Product Change Notification / GBNG-16RJZN641

CCB 4279.001 Initial Notice: Qualification of GTK as a new assembly site for selected SST38VF640xx, SST39LF40xx and SST39VF40xx device families available in 48L TSOP (12x20mm) package.

CCB 4279.001
Pre and Post Change Summary
PCN #: GBNG-16RJZN641

LPI

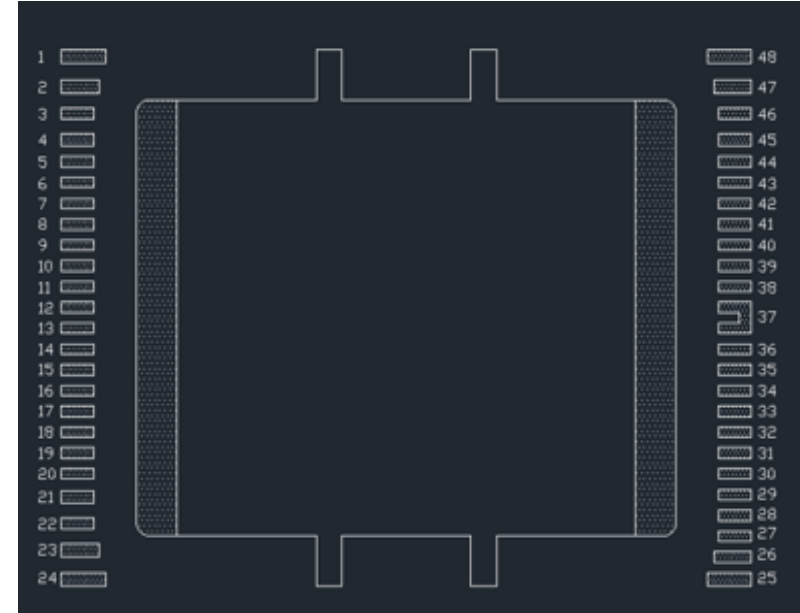
Paddle size

162 x 260 mils

GTK

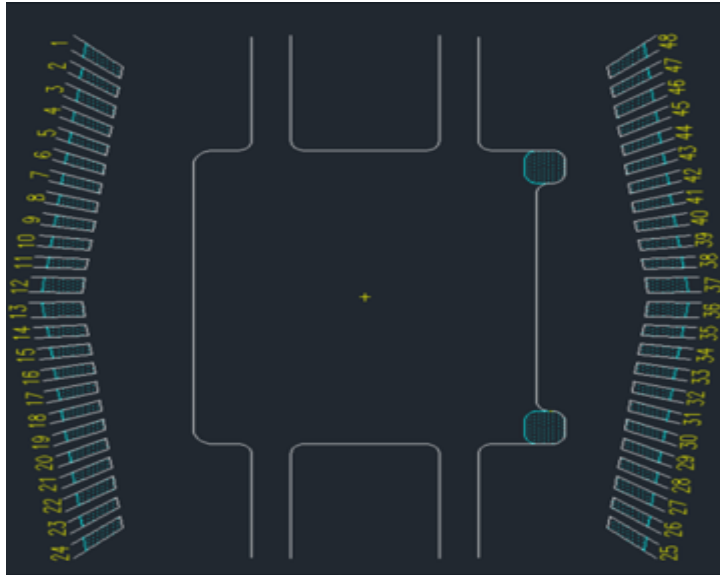
Paddle size

330 x 260 mils

GTK

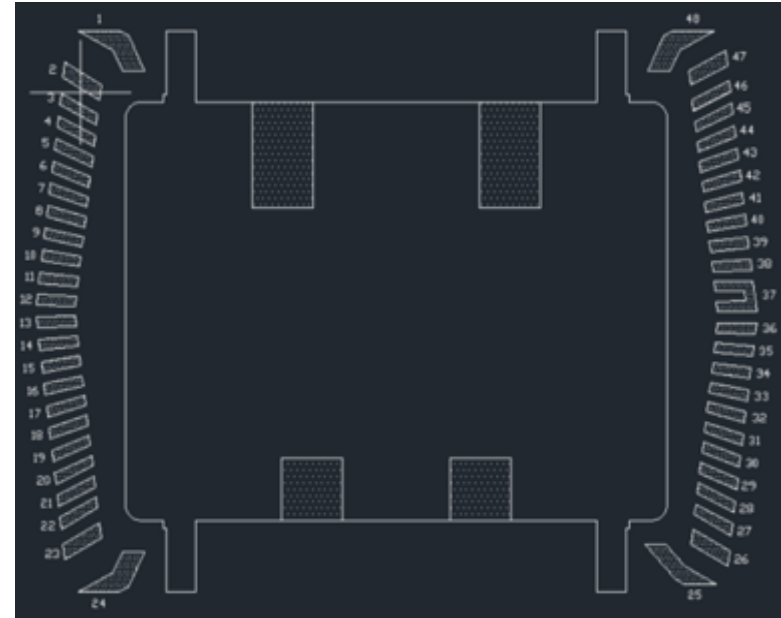
Paddle size

280 x 210 mils
